City of Manzanita

STAFF REPORT

TO: Manzanita Planning Commission
FROM: Walt Wendolowski, Contract Planner
SUBJECT: Planning File – Lot 13 Mixed-Use Design Review
DATE: August 9, 2021

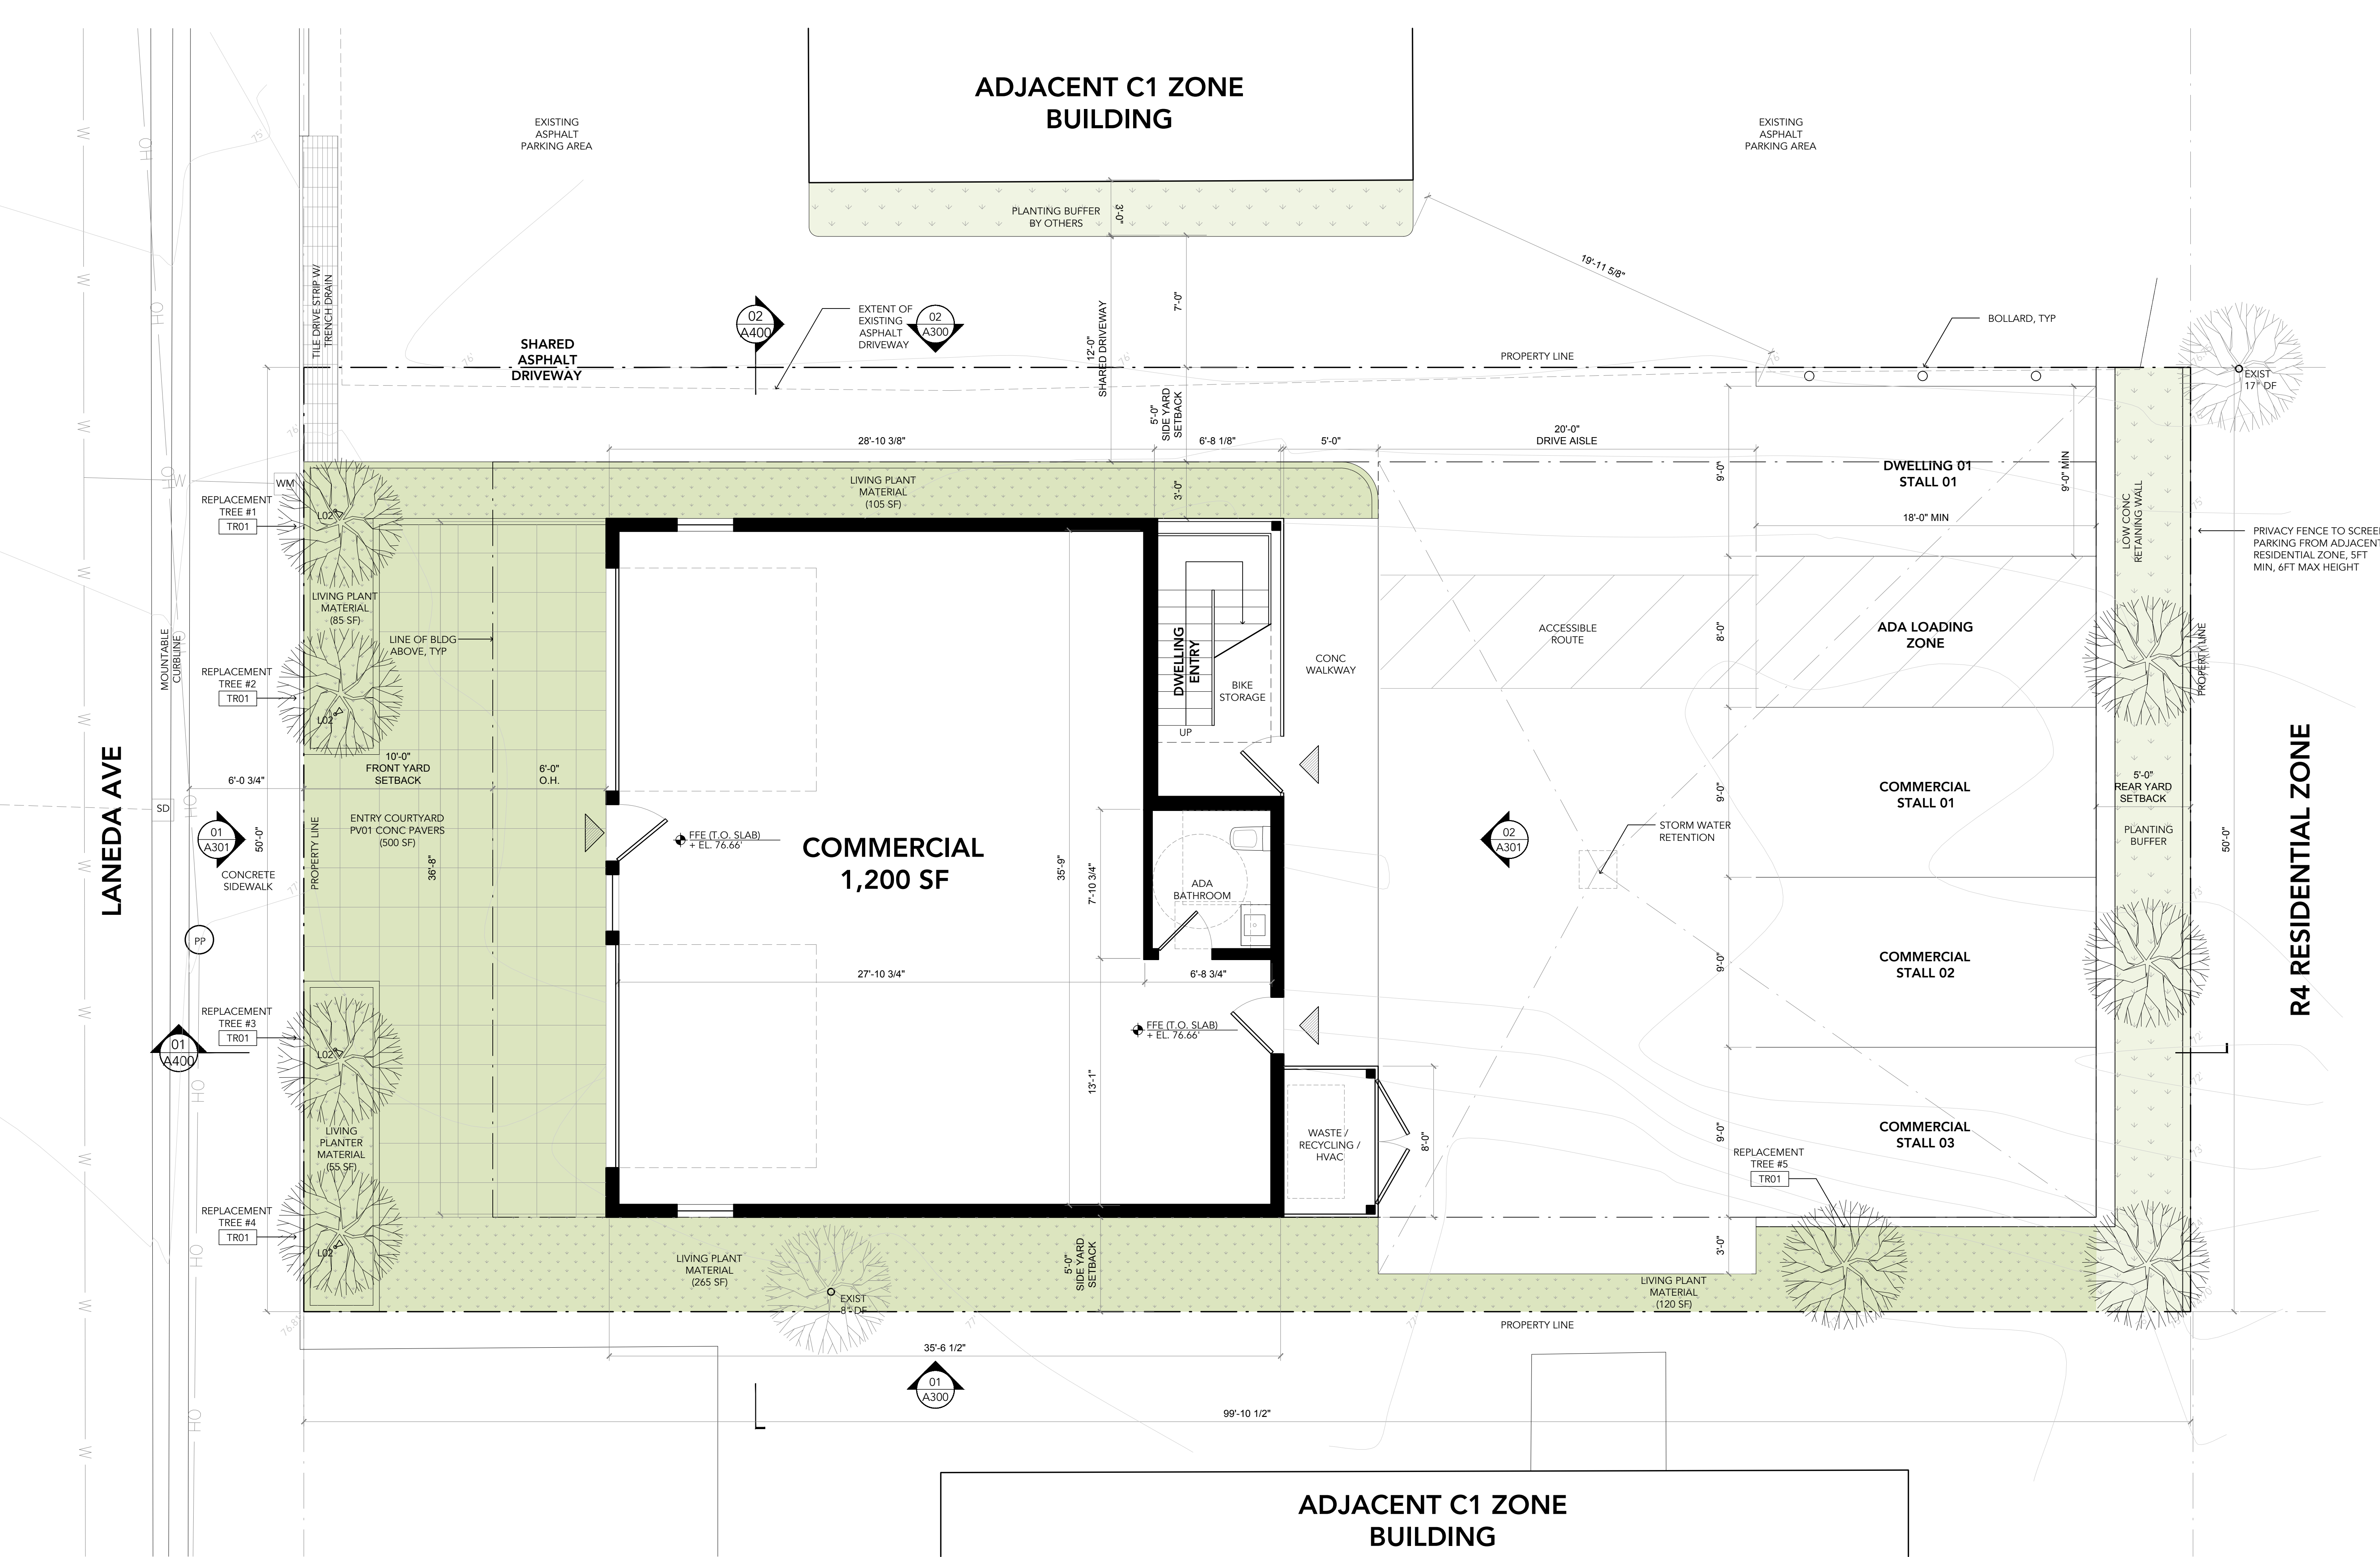
3. At least 10% of the 5,000 square foot site must be landscaped, or a minimum of 500 square feet. The site plan identifies 1,130 square feet of landscaping improvements, of which 630 square feet contain living plant material.

FINDINGS: As noted, above, only 500 square feet of landscaping is required, of which 50% or 250 square feet must be in living plant material. The site contains 1,130 of landscaping of which 630 square feet are in living plan material.

A300

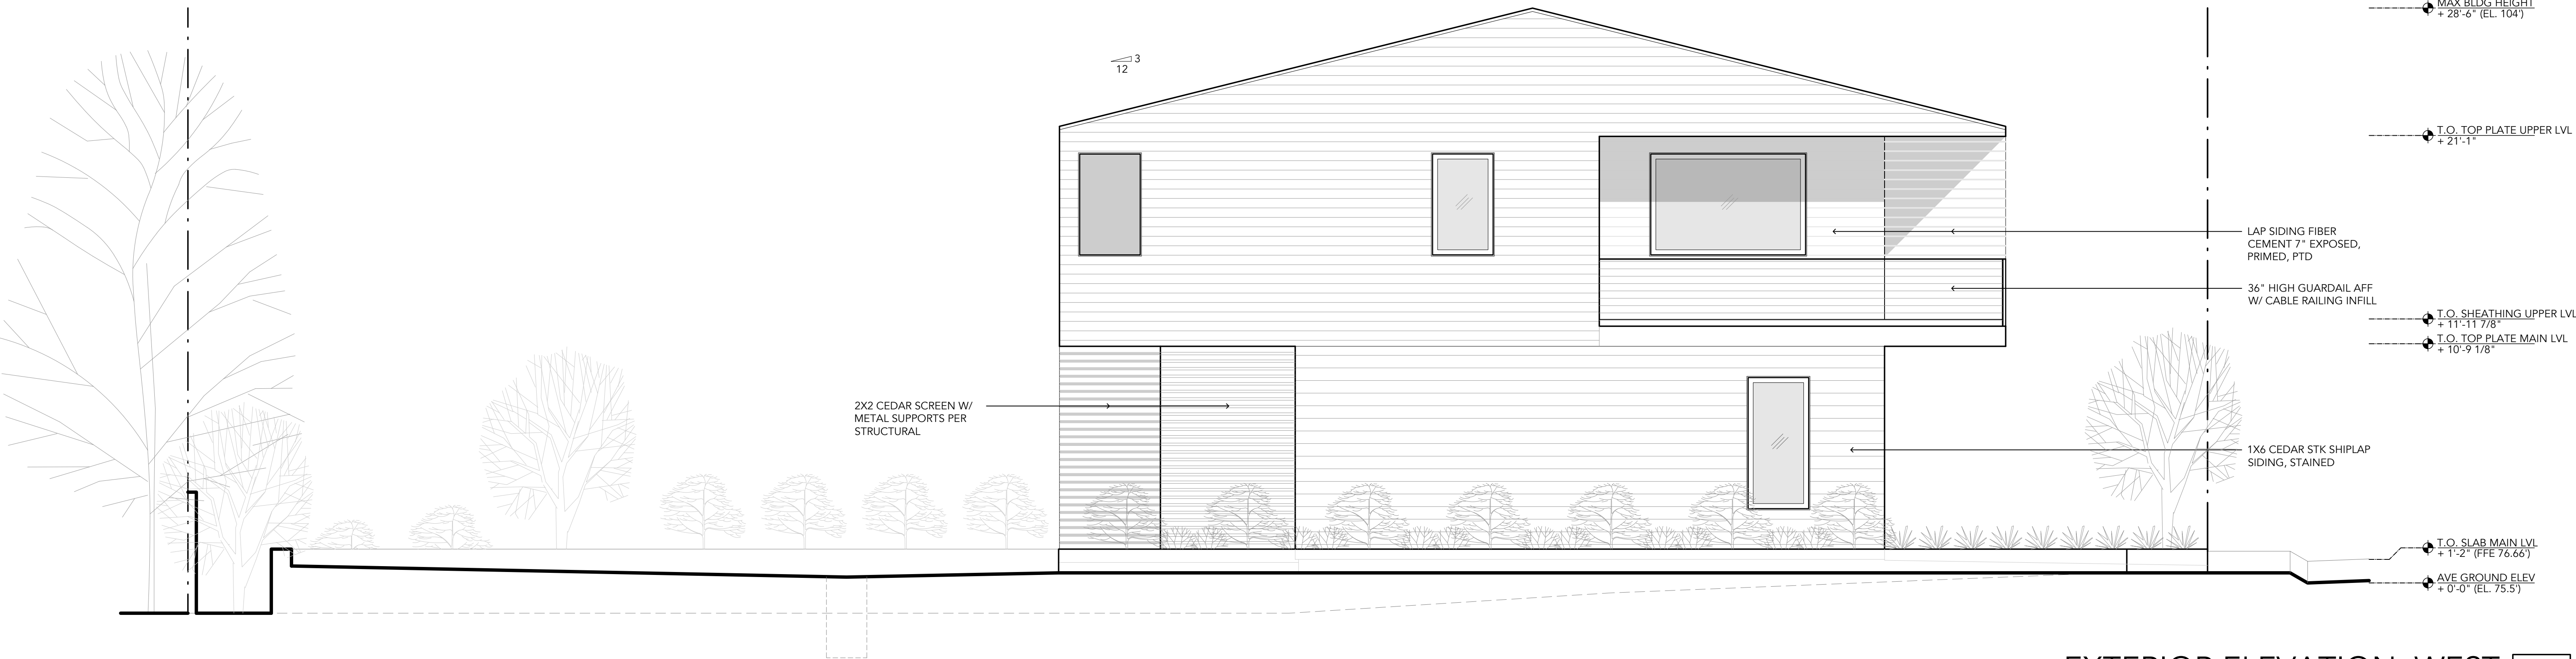
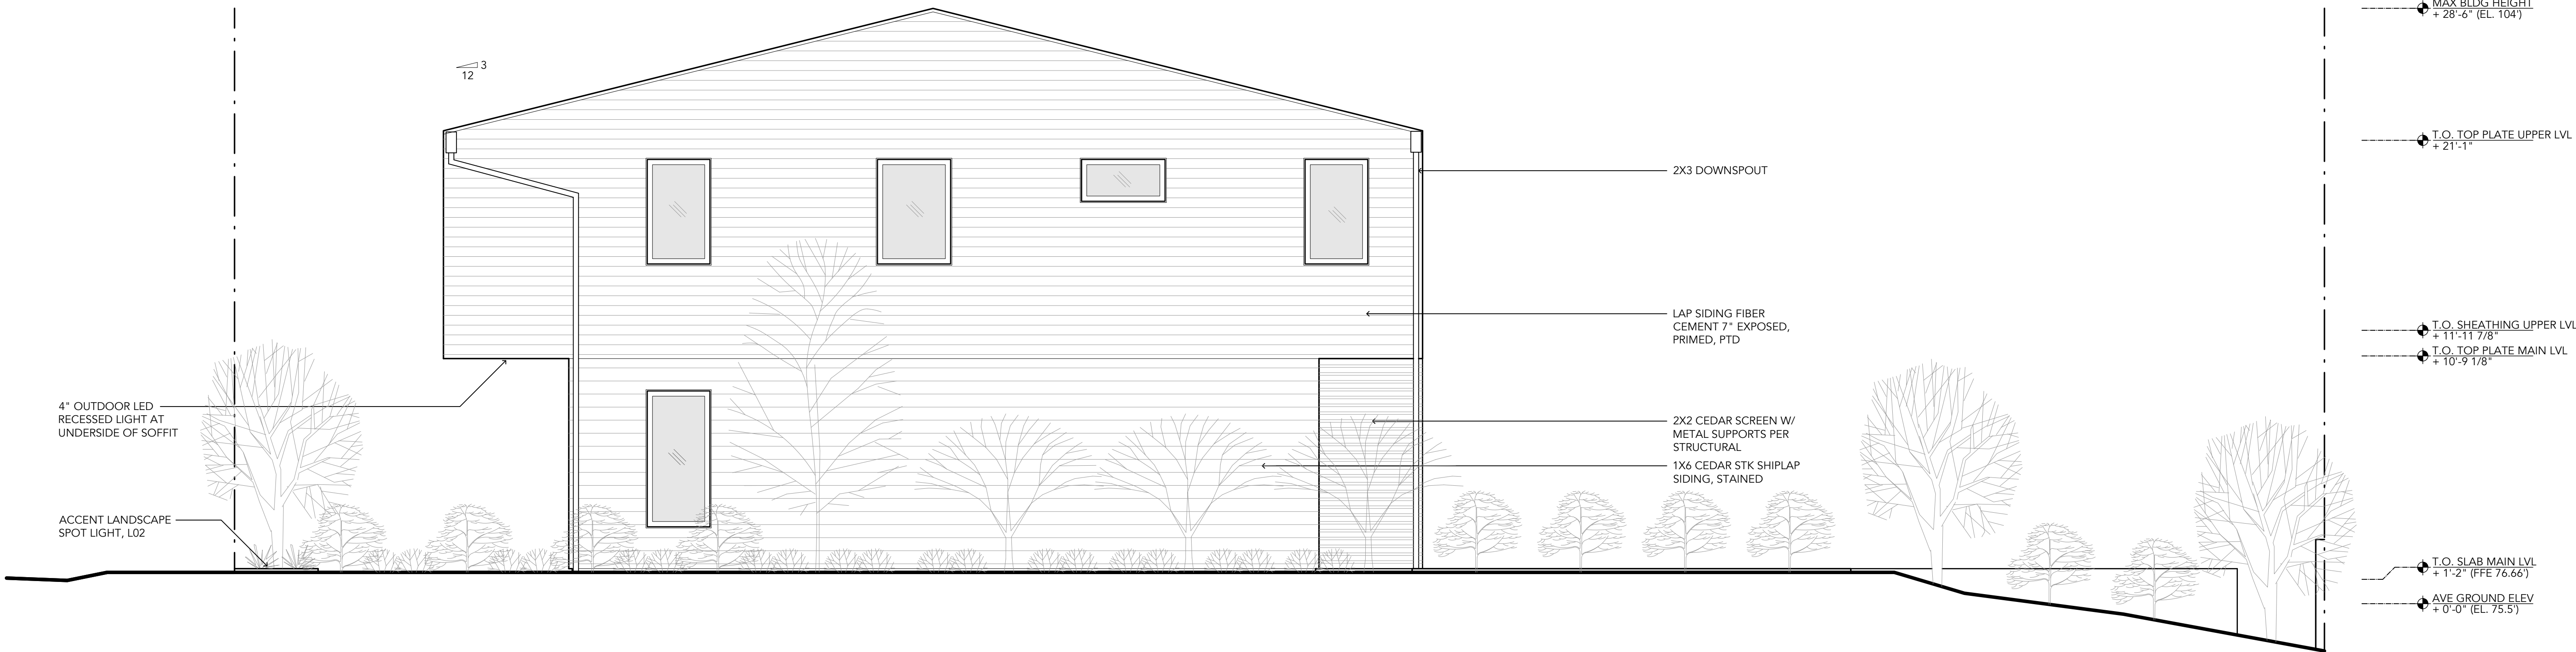
FINDINGS: The building is generally consistent in finish, color and style with a majority of the buildings in the vicinity. The structure utilizes a wooden exterior – as are many adjacent structures - and does not include the use of corrugated siding or similar metal finishes.

FINDINGS: Each floor has a different, but compatible, color scheme. This is further enhanced by different types of siding, wooden trim and the placement and size of windows. On balance, these provide a visual interest to the structure.
